Access Compliance Report

Public Rights-of-Way

(Curb Ramps)

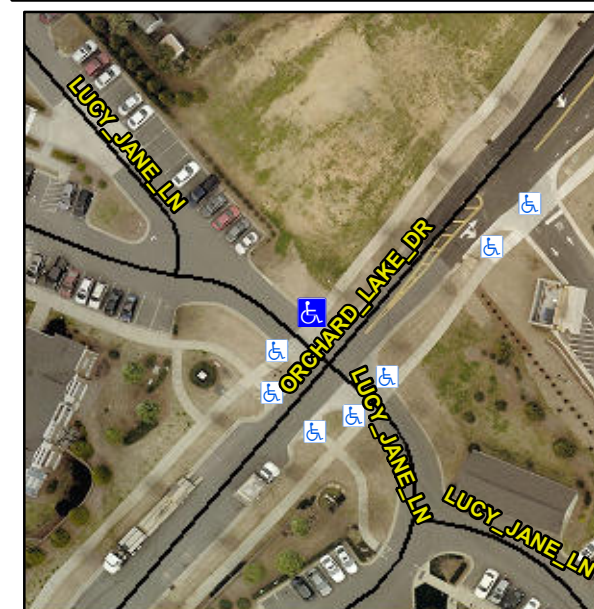
Not Found, R304.2.2-Perp, R304.3.2-Para, R304.5.3, R304.5.2, R305.1.4, R305.2

Remove & Replace Entire Ramp.
